# FIVE ESTUARIES OFFSHORE WIND FARM

## 10.20.1 TECHNICAL NOTE: METHODOLOGY FOR DETERMINING MDS (OFFSHORE)

Application Reference:	EN010115
Application Document Number:	10.20.1
Revision:	A
Pursuant to:	Deadline 2
EcoDoc Number:	005395492-01
Date:	October 2024

**Figure 3 Crossing dimensions**

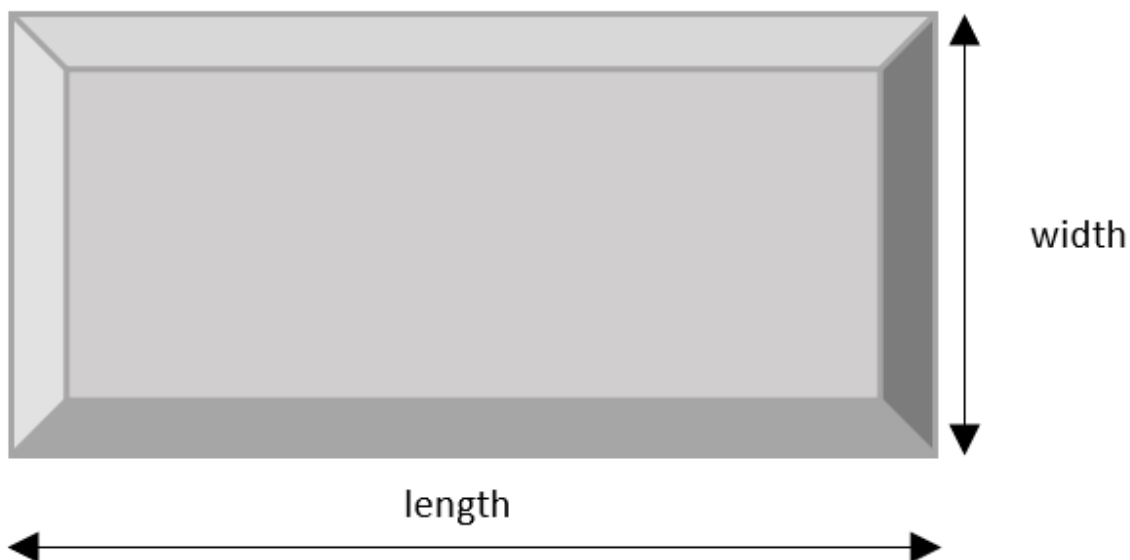
## 2. ISH1 – ACTION POINT 4: SELECTED MDS VALUES FOR EXPLANATION

2.1.4 Cables crossings and external protection are described in section 3.7.5 of 8.1 Cable Statement [[APP-229](#)]. To aid in the understanding of the terms used, Figure 1 is provided. Please note that the cover layer is the same as the “secondary layer”. For clarity a typical concrete mattress is shown in Figure 2 For crossings, multiple concrete mattresses may be used to provide the necessary separation and cover. Figure 3 provides a guide to help understand the values quoted in the MDS.

2.1.5 The values assumed in the MDS are typical values from experience and no project specific design has been conducted. In detailed design either rock berms or mattresses will be chosen and detailed design will be conducted to confirm the hydrodynamic, mechanical and electromagnetic suitability of the design. The Applicant notes that the conditions at site are within normal ranges for the design of crossings.

**Figure 4 Sediment dispersal during jetting (IMCA Code of Practice for Offshore Cable Laying in the Renewable Energy Industry M264 Rev. 0.1 – November 2023)**

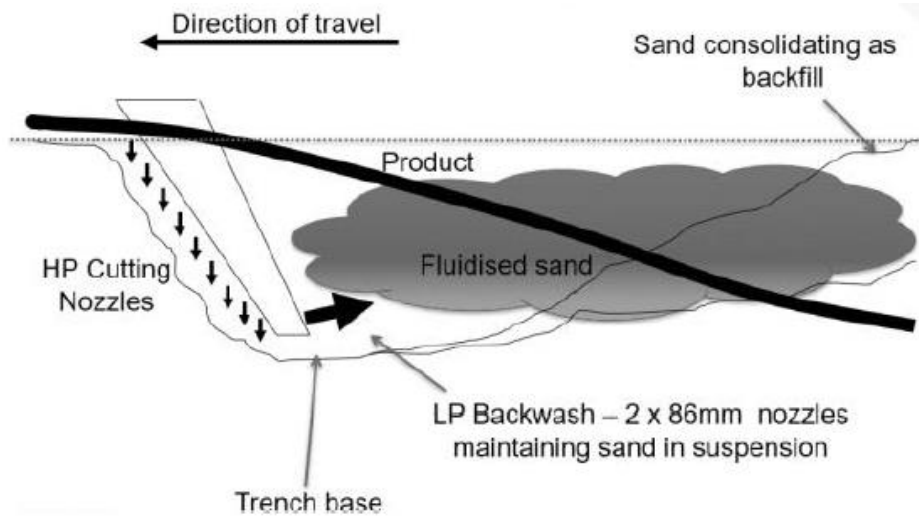
## 2.4 FLUIDIZED MATERIAL (50% ASSUMPTION)

- 2.4.2 The values in this table are estimated with a 50% assumption, regarding the amount of sediment disturbed. This value is used because during the trenching not 100% of the material is dispersed into the water column. An example of this for jetting is shown in the sketch in Figure . Some of the sand is fluidized into the water column and may disperse, however some backfills over the cable. The values in the table for the maximum volume are calculated from a typical average burial depth of 1.75 m, the maximum value of 3.5 m is a maximum indicative value. The actual burial depth will be below the average, hence this value has been used to assess the impact of sediment dispersal on sensitive receptors in the marine environment.

**Figure 5 Maximum length of cable in SAC**

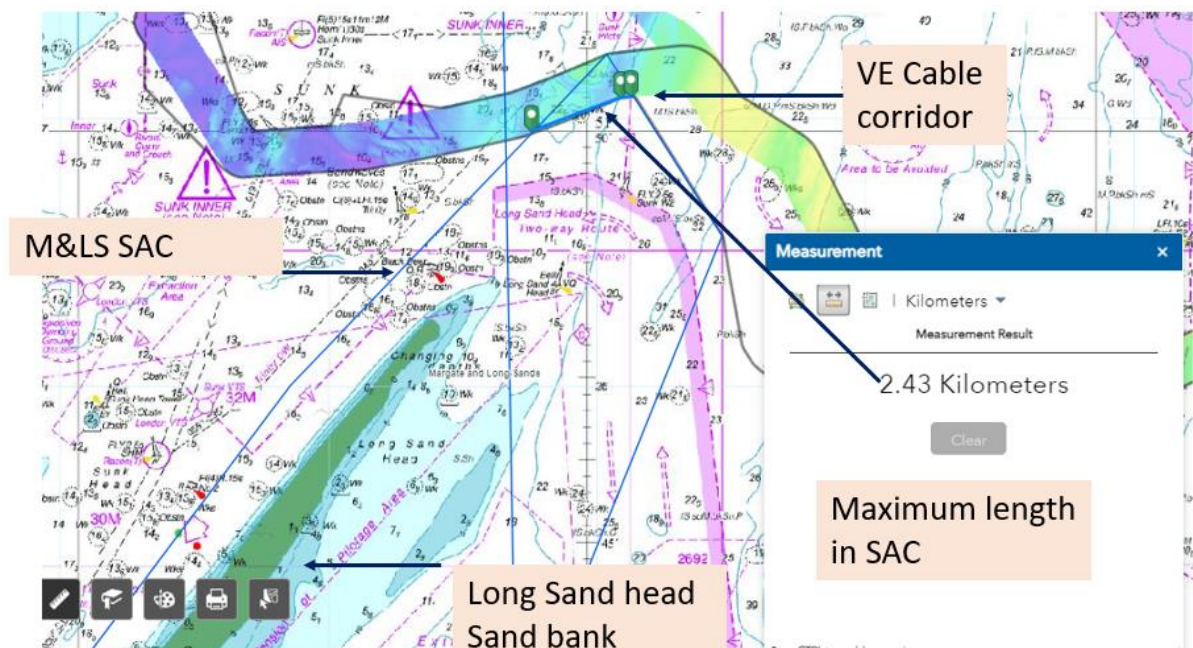
#### 3.1 HOW HAS MAXIMUM LENGTH OF CABLE PROTECTION REQUIRED WITHIN MARGATE AND LONG SANDS (MLS) SPECIAL AREA OF CONSERVATION (SAC) BEEN DETERMINED?

3.1.1 Theoretical max single cable length is estimated at circa 2.5 km as shown in Figure 5 below. It can also be seen that the Long Sand Head sand bank feature is 4-5km from the cable corridor and separated by the Long Sand Head two way route (Shipping Lane) used by vessels transiting to the ports.

- 3.1.2 This would be hugging the southern corridor edge. The project cannot conduct the final routing until post DCO, however the Applicant has committed to the following *“Final cable routing will seek to take the shortest route through the M&LS SAC where possible”* (9.13 Margate and Long Sands SAC Benthic Mitigation Plan [APP-243 Table 9.1]).

- 3.1.4 Based on the preliminary work conducted to date this is resulting in indicative routes with between 0.4-1.5km within the SAC.

3.1.5 A highly conservative assumption of 50% of the cable would require protection has then been applied to an assumed routing of 900 m per cable in the SAC. This has been combined with an assumed mattress width of 6m to result in the 5,400 m<sup>2</sup>. This value is considered highly conservative by the Applicant and the most likely scenario is that no external cable protection will be used.
